LOCATION 3 Cherry St

TO: Inspections
FROM: Jay Reynolds, Development Review Coordinator
DATE: November 2, 2001
RE: C. of O. for # 3 Cherry Street

DATE: 18/June/96 ADDRESS: 3 Cherry ST.
 REASON FOR PERMIT: To Construct a single family dwelling.
 BUILDING OWNER: Jonel Pastolacke
 CONTRACTOR: 11 11 11 APPROVED: *1*7*9*11
 PERMIT APPLICANT: 11 11 ~~REVIS~~: *13*14*15*16.

RE: Postolache Residential Property at 3 Cherry Street, Portland, ME

3 CHERRY ST
AMENDED ROOF
(SKETCHES)
WITH DORMERS ADDED

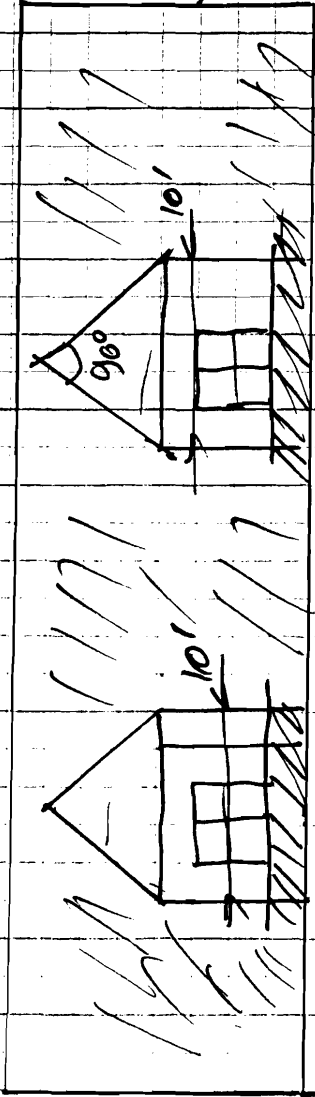
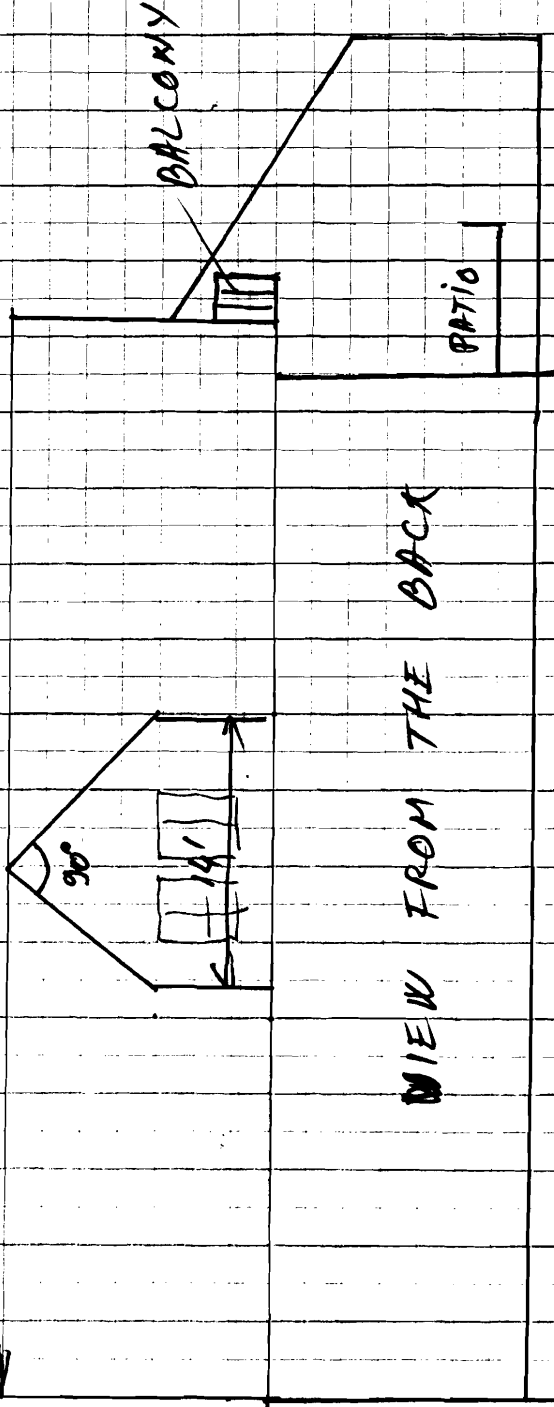
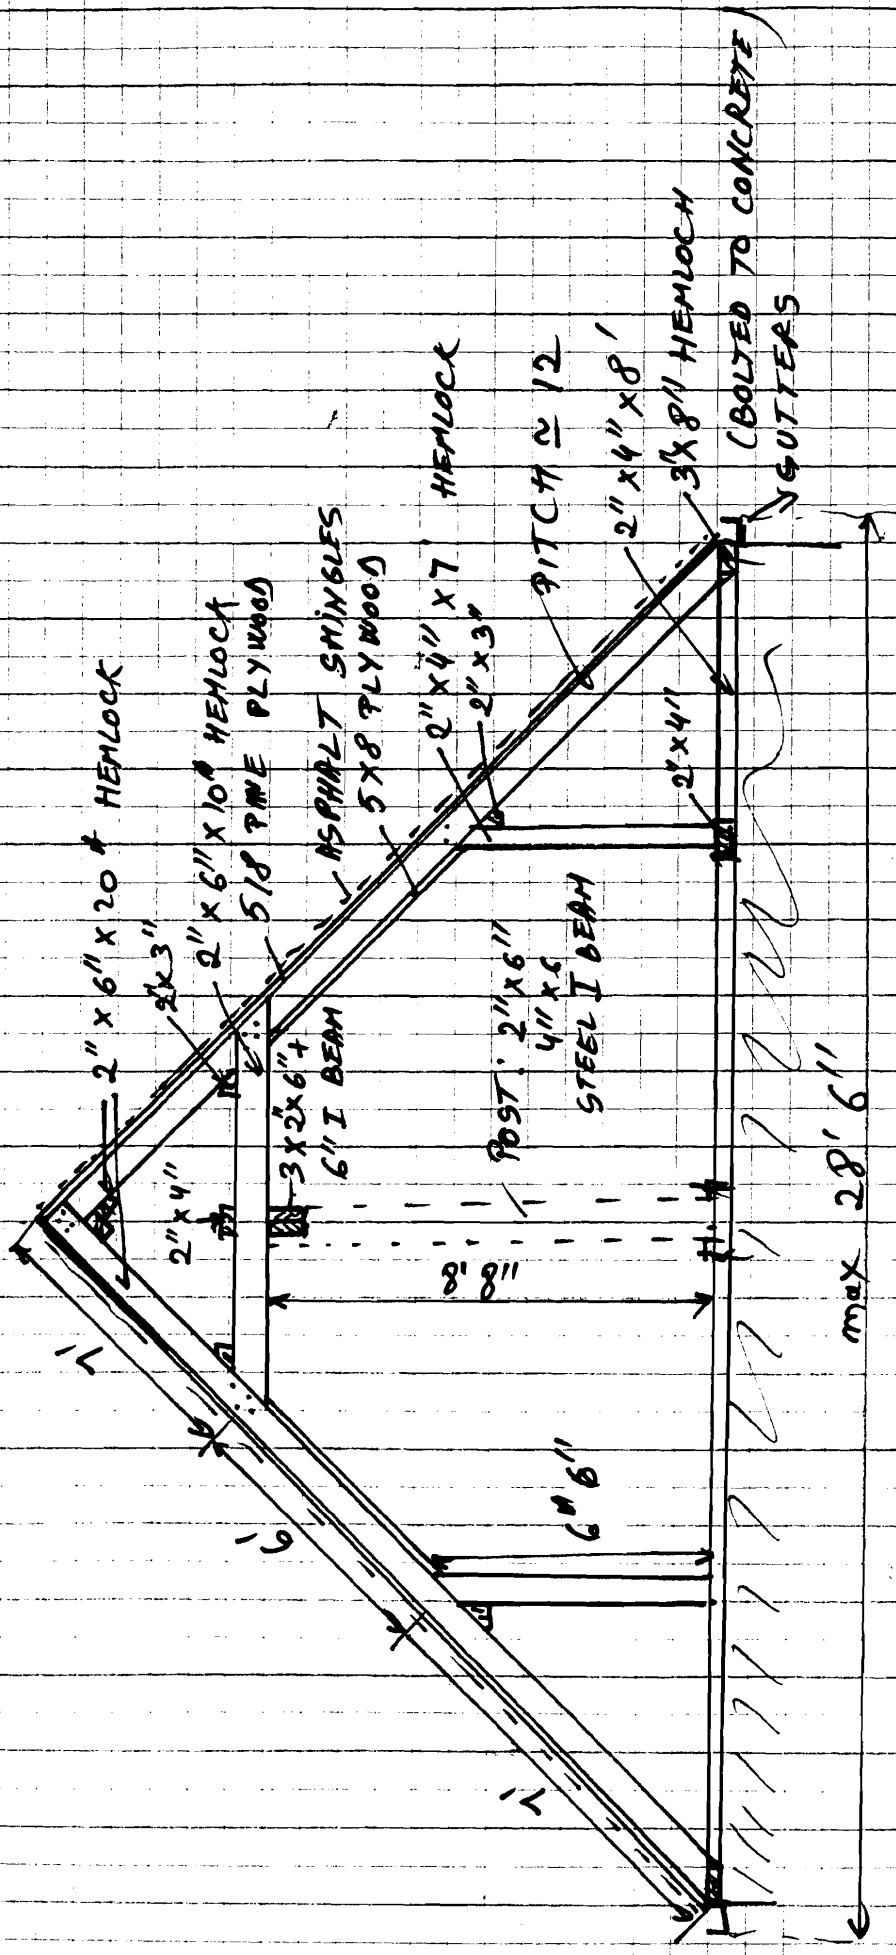
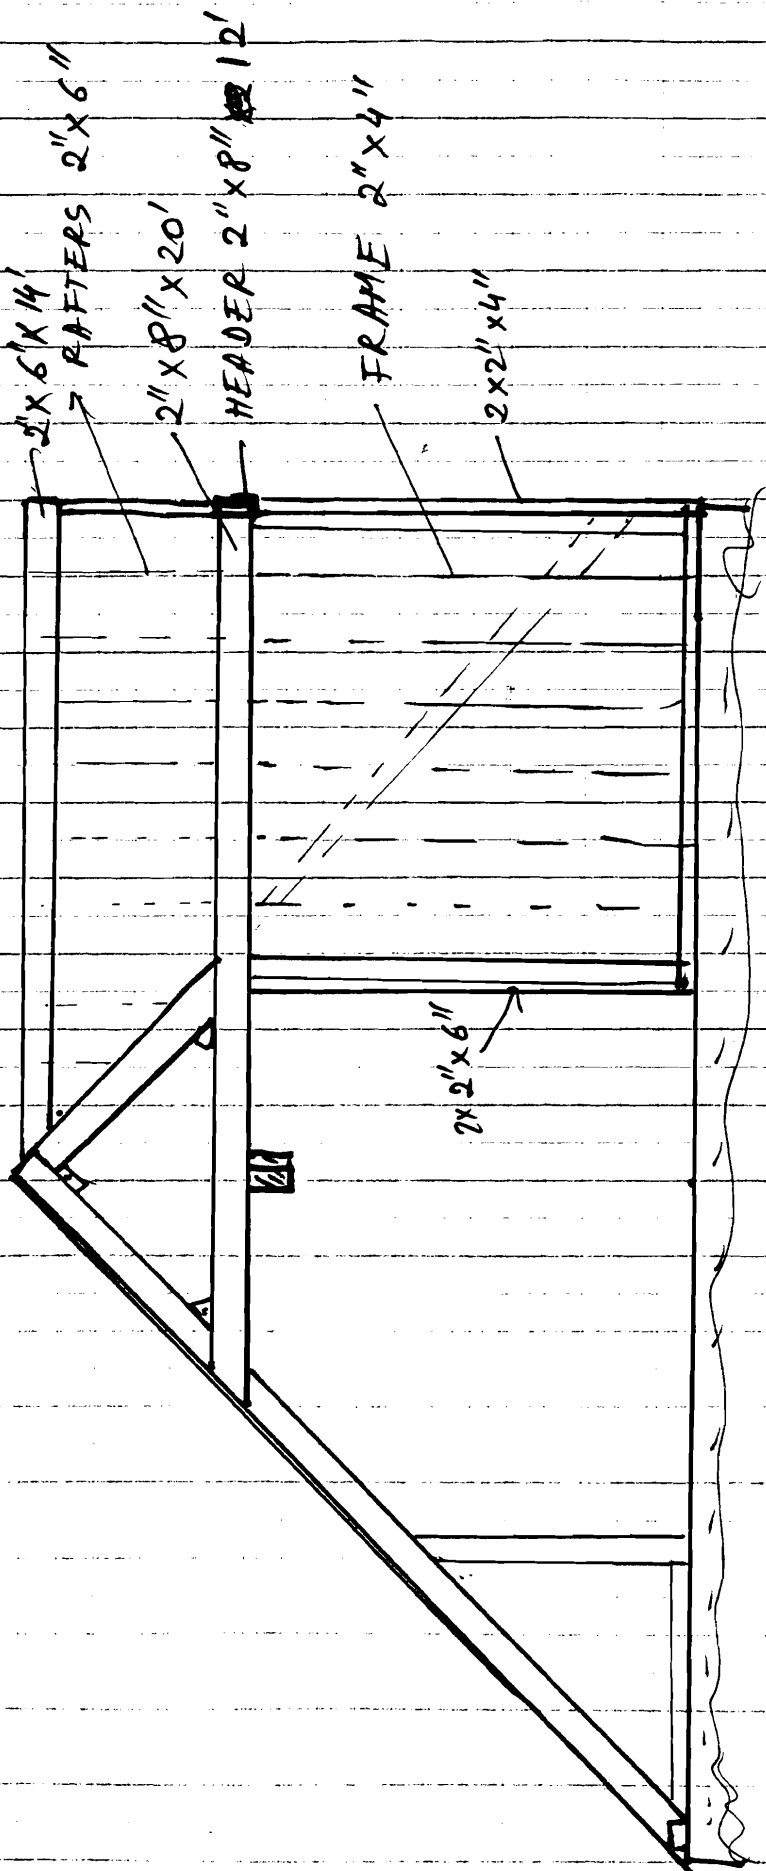
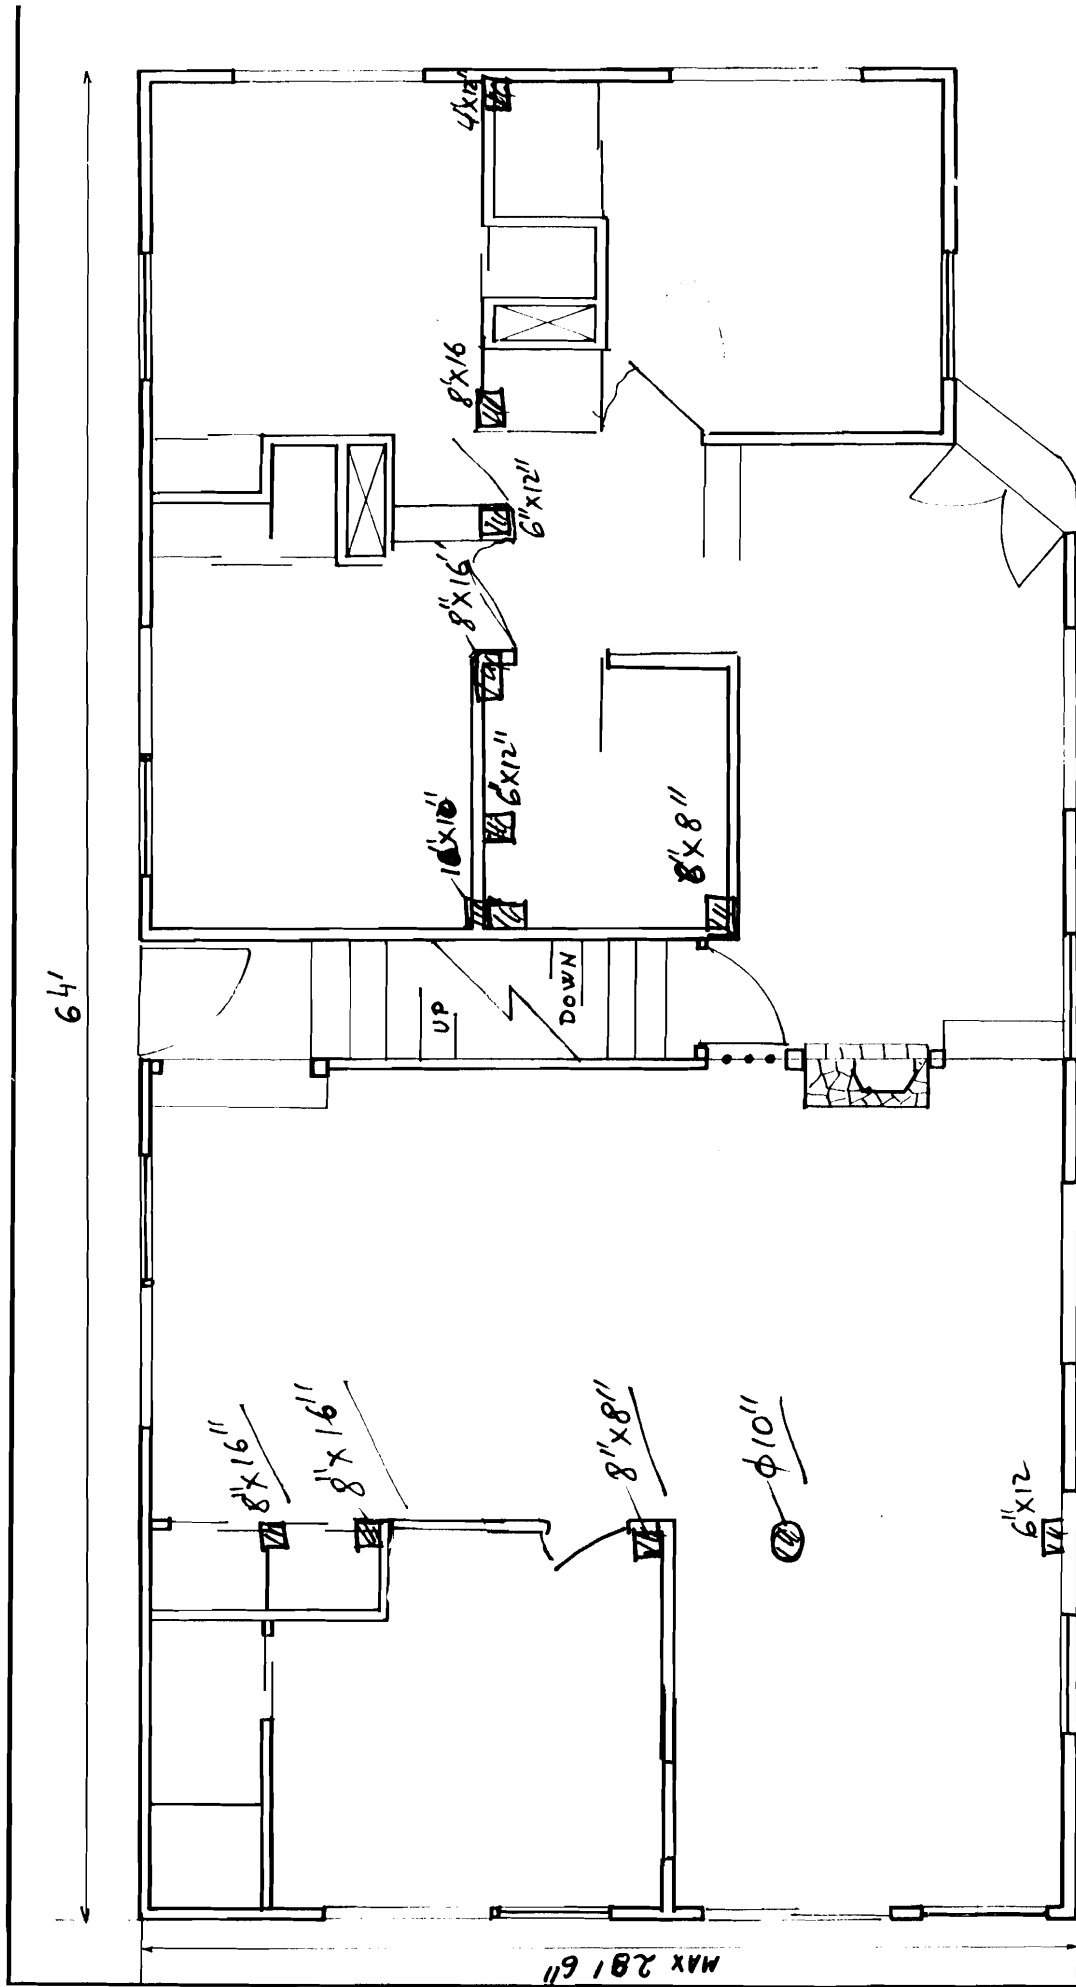
7. Right now I am trying to evaluate- aesthetically - the impact of adding dormers to the roof. When that is finalized, the structure of the roof will bring some changes to the structure of the first floor and basement- basically added pillars- that I want, wether they are required by the code or not, where I want them to be.

BASEMENT 3 CHERRY ST
 PERMIT # 960576

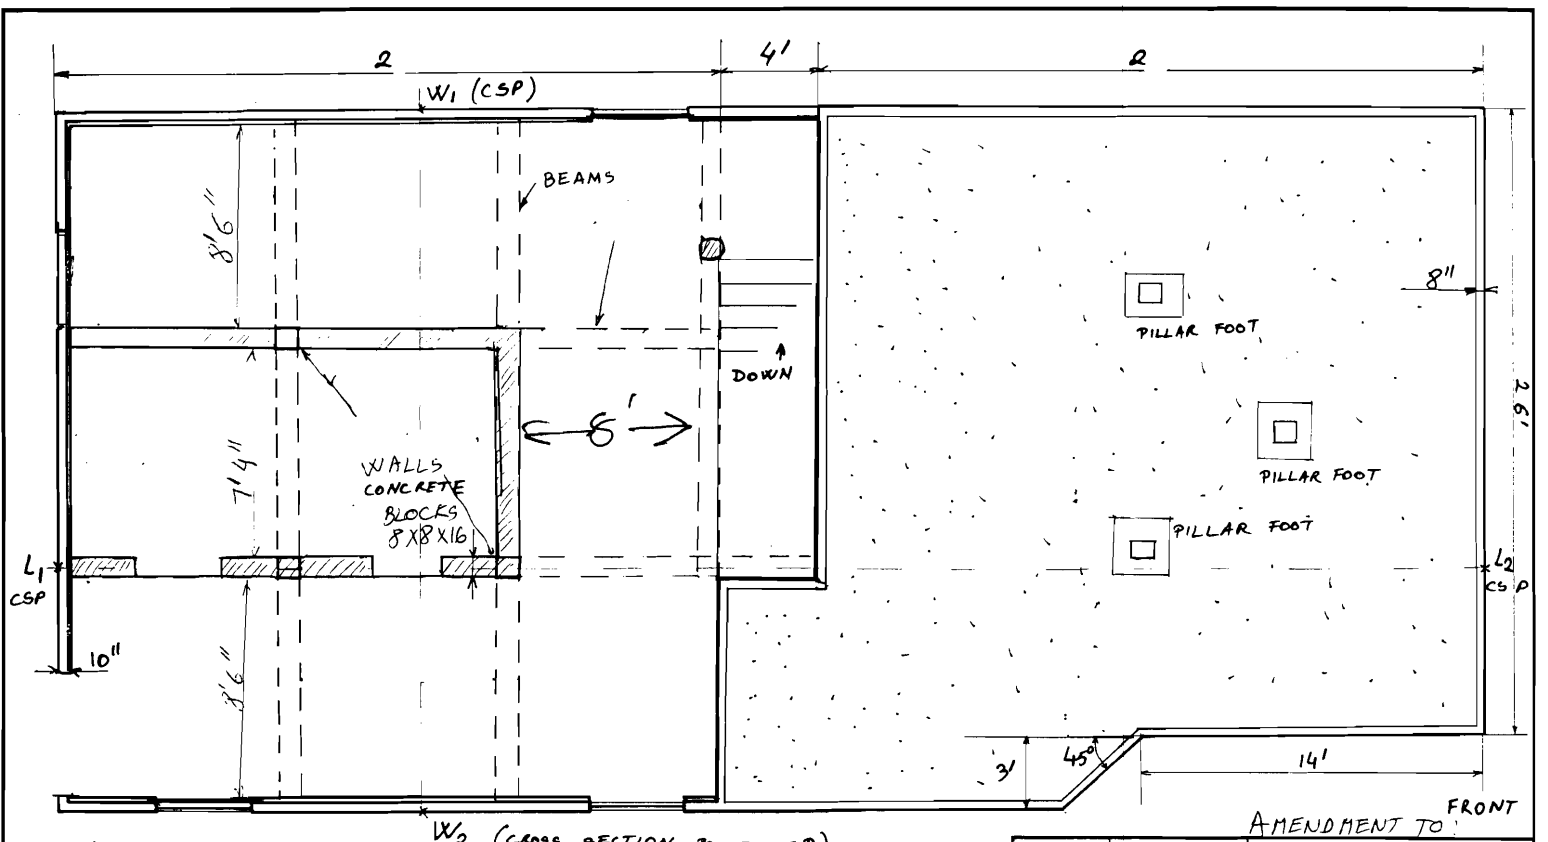
I also attached the amendment to the basement, indicating the positioning and dimensions of the partition walls from the basement; they will be built just before the house will be ready to move in.
